Access Compliance Report Public Rights-of-Way (Curb Ramps)

Main Street: IRVINE_BLVD Cross Street: N/A Location: W

ADA ID: RPAT211027110327 Ramp Type: Type 1 - Perpendicular Diagonal Initial Pass/Fail: Fail Overall Compliance: No Severity Score: 16

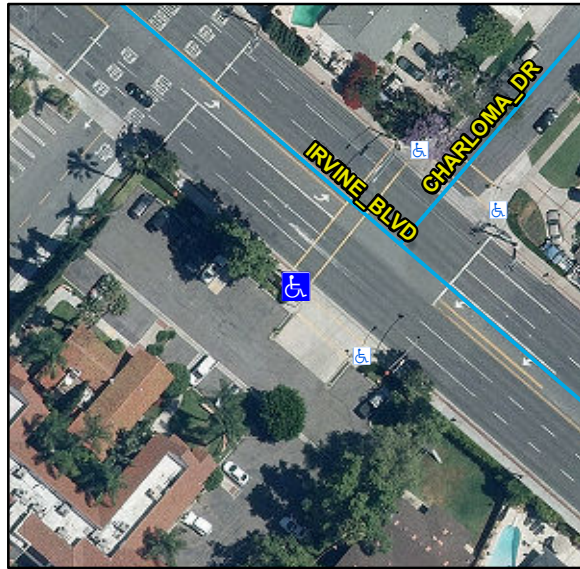
Compliance	Description	Data	Compliance	Description	Data
N/A	Ramp Length (in)	88	N/A	Flare Type LT	
Yes	Ramp Width (in)	48			N/A
No	Ramp Run Slope (%)	11.9	N/A	Flare Slope LT (%)	N/A
No	Ramp Cross Slope (%)	3.1	N/A	Flare Traversable LT	N/A
N/A	Landing Present	N/A	N/A	Flare Type RT	
N/A	Landing Length (in)	N/A			N/A
N/A	Landing Width (in)	N/A	N/A	Flare Slope RT (%)	N/A
N/A	Landing Run Slope (%)	N/A	N/A	Flare Traversable RT	N/A
N/A	Landing Cross Slope (%)	N/A	N/A	DWS Provided	N/A
N/A	Landing Movement Obstructed?	N/A	N/A	DWS Contrast	N/A
	Landing Movement Type	N/A	N/A	DWS Length (in)	N/A
N/A	Landing Shared	N/A	N/A	DWS Full Width	N/A
N/A	Clear Space	Yes	N/A	DWS Offset Left (in)	N/A
N/A	Clear Space To Crosswalk (in)	48	N/A	DWS Offset Right (in)	N/A
N/A	Marked Crosswalk 1	Yes	N/A	Marked Crosswalk 2	Yes
	Crossing 1 Direction	NE		Crossing 2 Direction	SE
	Marked Crosswalk 1 Width (in)	120		Marked Crosswalk 2 Width (in)	120

N/A	Ramp Inside Crosswalk 1	Yes	Yes	Ramp Inside Crosswalk 2	Yes
	Crossing 1 Slope (%)	2.1		Crossing 2 Slope (%)	6
	Crossing 1 Cross Slope (%)	1.6		Crossing 2 Cross Slope (%)	1.1
N/A	Gutter Ponding	N/A	No	Curb Slope	8.4
Yes	Gutter Lip Height (in)	0		Road Run Slope (%)	2
N/A	Gutter Run Slope (%)	N/A		Road Cross Slope (%)	3.3
N/A	Gutter Cross Slope (%)	N/A			
Yes	Overall Surface Condition: Acceptable		Yes	Perp Joint Present	Yes
	Cross Gutter Present?	Yes		Spandrel Present?	Yes
	Replace Cross Gutter?	No		Replace Spandrel?	No

Remove & Replace Curb Ramp With Two New Directional Ramps or Equivalent.
